Stellaris[®] LM3S5R31 RevB1 Errata

This document contains known errata at the time of publication for the Stellaris[®] LM3S5R31 microcontroller. The table below summarizes the errata and lists the affected revisions. See the data sheet for more details.

Figure 1. Workaround Circuit to Ensure Initial Power Up

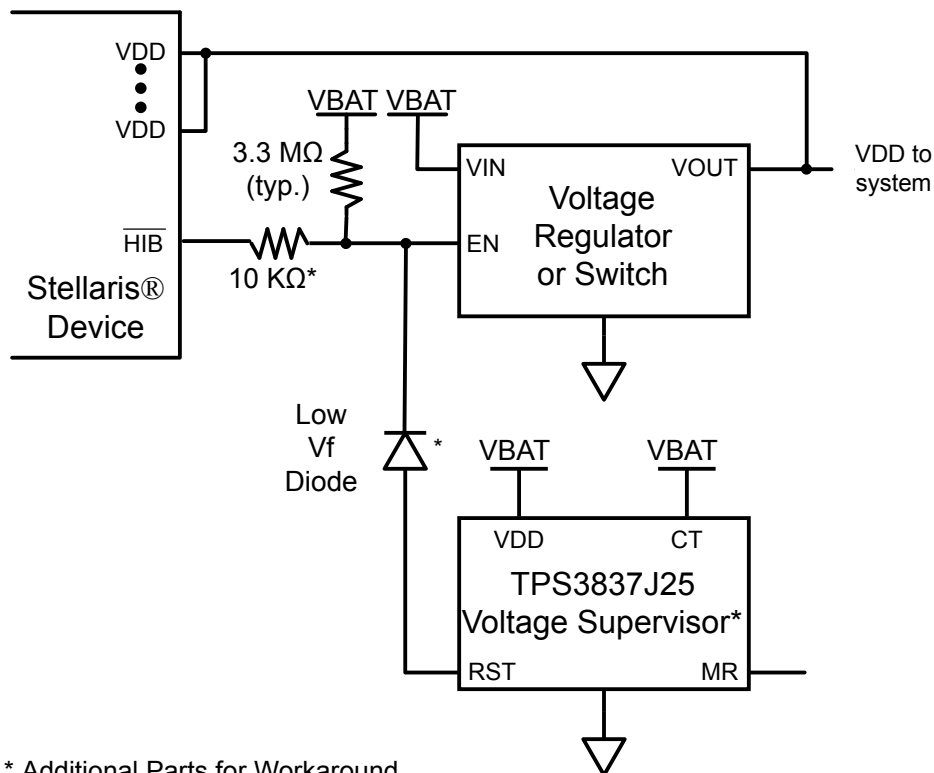
If V_{DD} is not powered when voltage is first applied to V_{BAT} , the state of the Hibernation module is indeterminate and the \overline{HIB} signal may be asserted. In this indeterminate state, a lock condition can occur in which the Hibernation module waits for a power-on-reset, but that reset cannot occur until the module deasserts \overline{HIB} . This issue is related to the errata "Hibernation module may have higher current draw than specified in data sheet under certain conditions" on page 5.

The workaround implementation depends on the system-level power supply configuration. For systems that use a battery as the primary power source, an external voltage supervisor (TPS383J25DBV or similar) circuit can be added to force the V_{DD} power supply to start when the battery voltage is first applied (see Figure 1). The voltage supervisor requires only 220 nA and generates a 200-ms positive pulse to turn on the V_{DD} regulator and activate the microcontroller's internal POR circuit.

Figure 2. Configuration of External Regulator

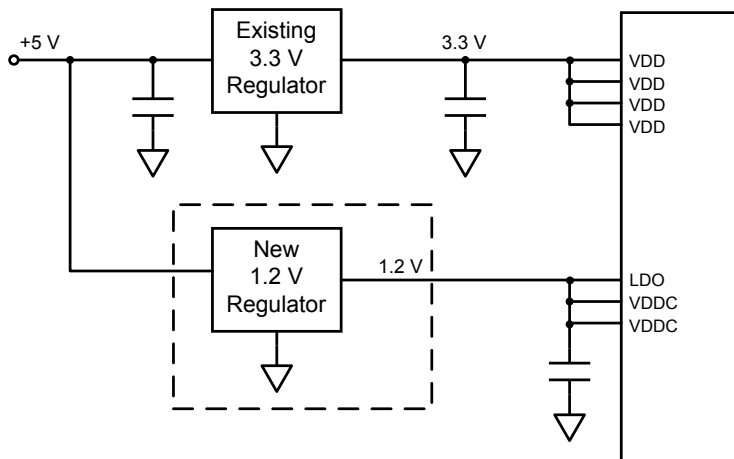
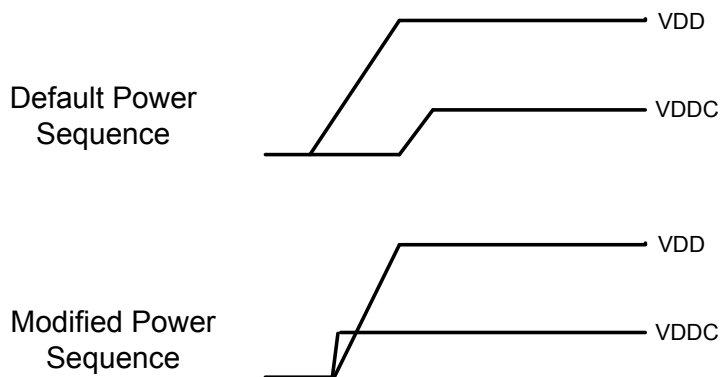
Incorrect power sequencing during power up can disrupt operation and potentially cause device failure.

V_{DDC} must be applied approximately 50 μ s before V_{DD} . Normally V_{DDC} is controlled by the part's internal LDO voltage regulator. The workaround requires the addition of an external regulator (see Figure 2) to ensure that V_{DDC} sequencing requirements are met (see Figure 3). Recommended regulators include FAN1112SX (SOT223) and FAN2558S12X (SOT23-5).

This fix mitigates the on-chip power issue, but does not solve it completely. During development, the Flash memory should also be reprogrammed (using LMflash or another programming tool) at least once a week.
